DOCUMENT 00 90 00 ADDENDUM

ADDENDUM NO. [2] Date: March 6, 2018

HIGH SCHOOL AND MIDDLE SCHOOL SECURE ENTRANCES

HOLMEN, WISCONSIN 54636 HSR PROJECT NO. 17071

ELECTRICAL REMOVAL PLANS

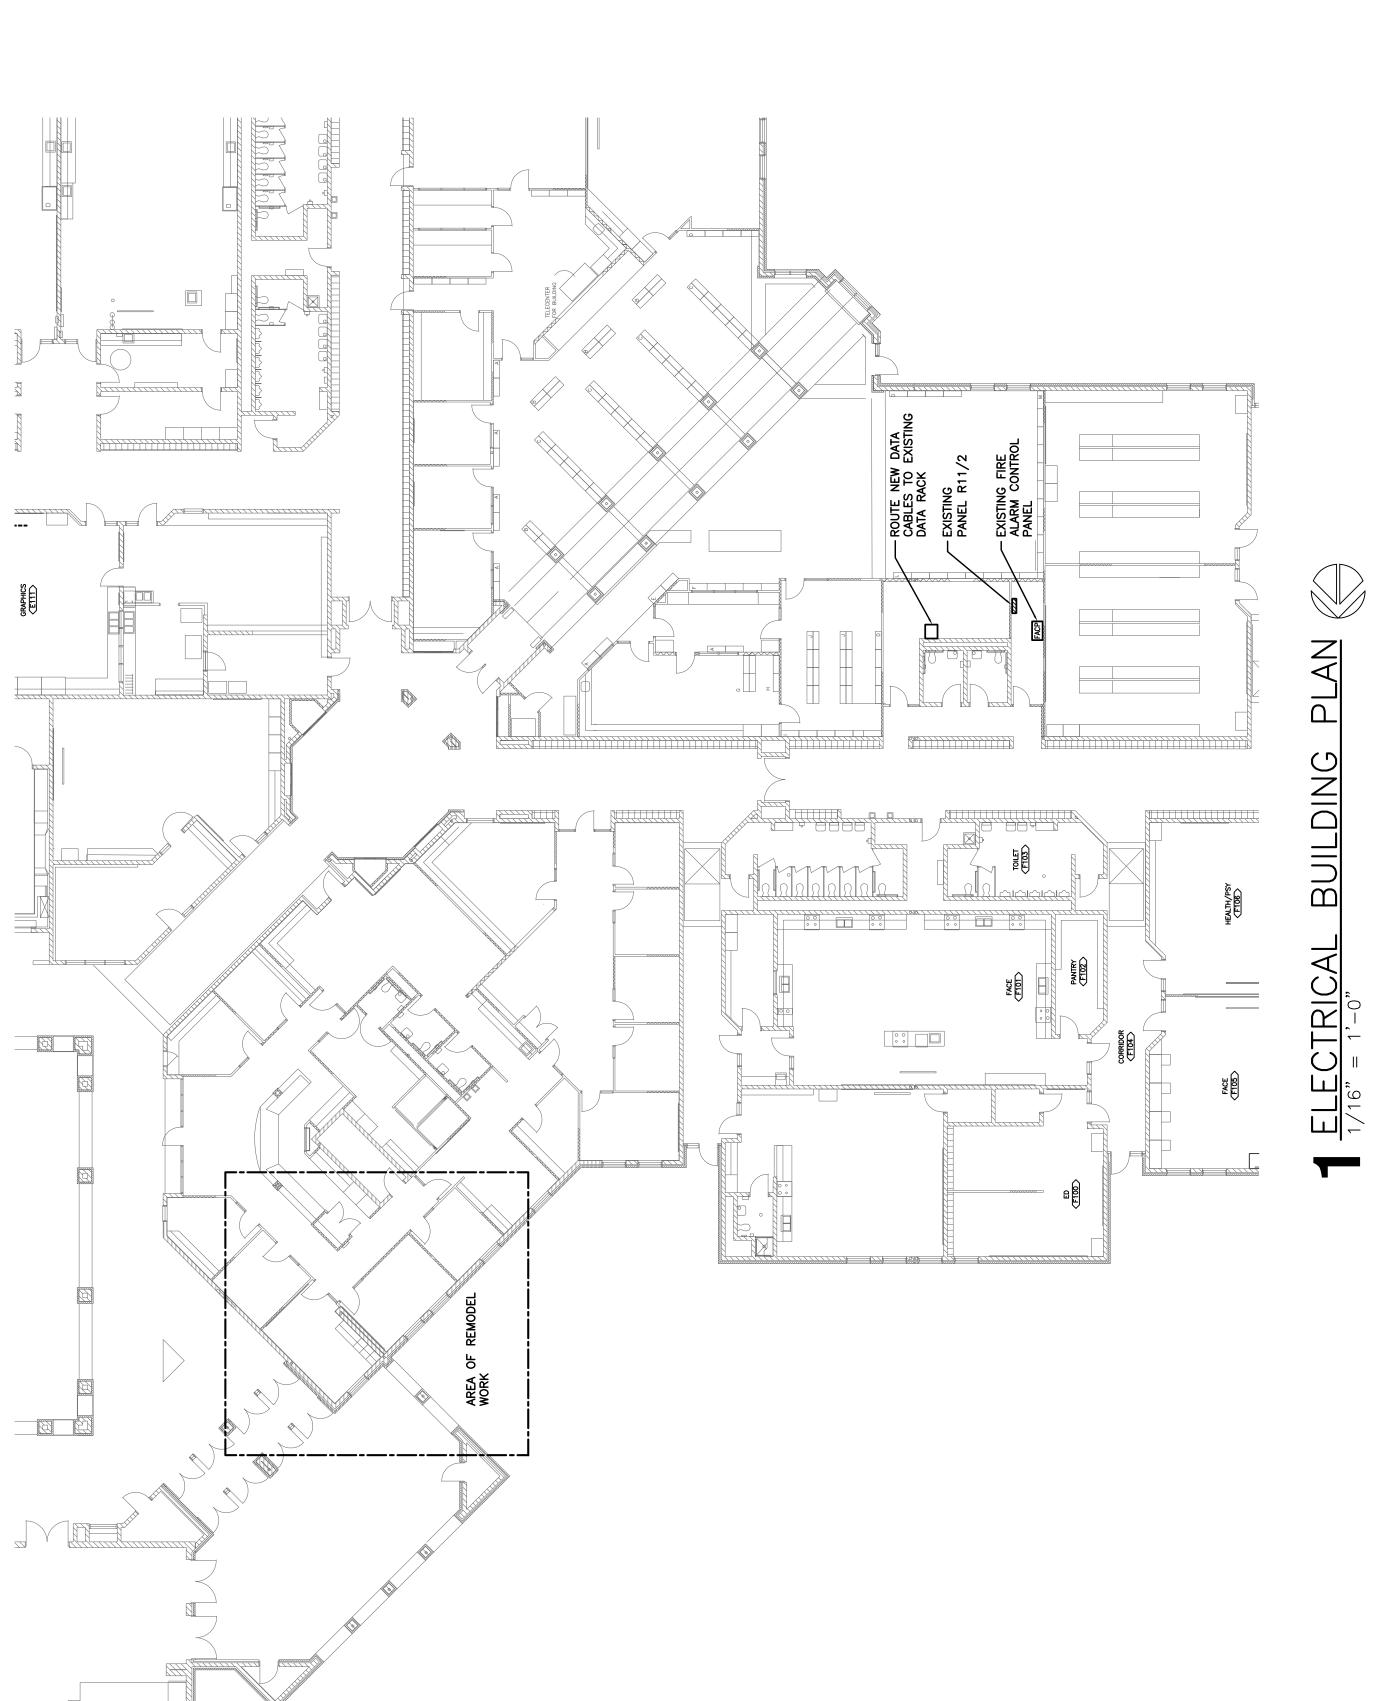
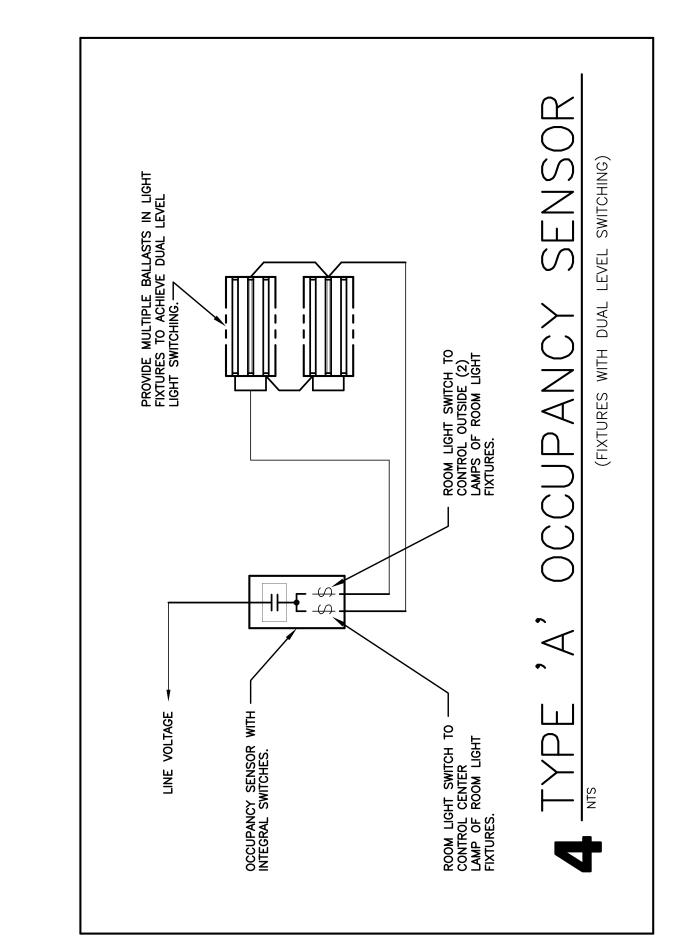
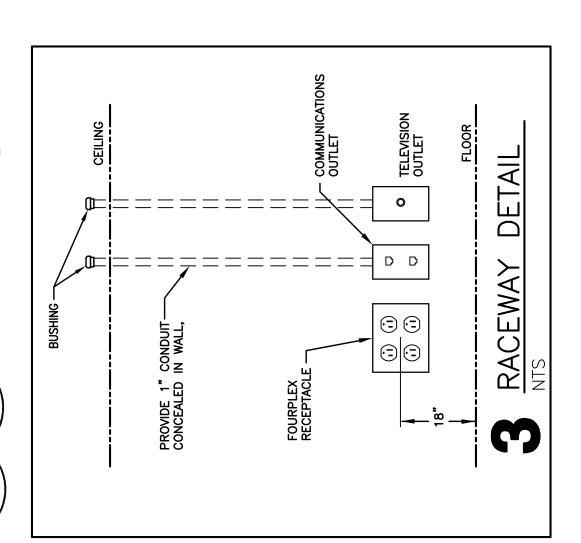
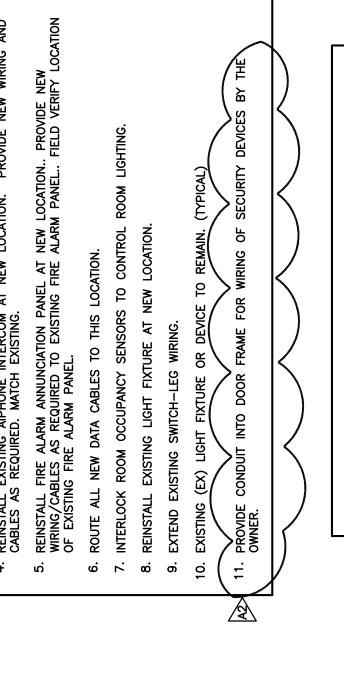
- 8. Sheet E090R ELECTRICAL REMOVAL PLANS 24 x 36 attached hereto
 - a. Revisions clouded on Drawing
 - b. Light fixture schedule: fixture types A, AD, AL, ALE, B and BD; Change catalog number to "LSER" series in lieu of (LTRE).
- 9. Sheet E100R POWER AND LIGHTING PLANS 24 x 36 attached hereto
 - a. Revisions clouded on Drawing
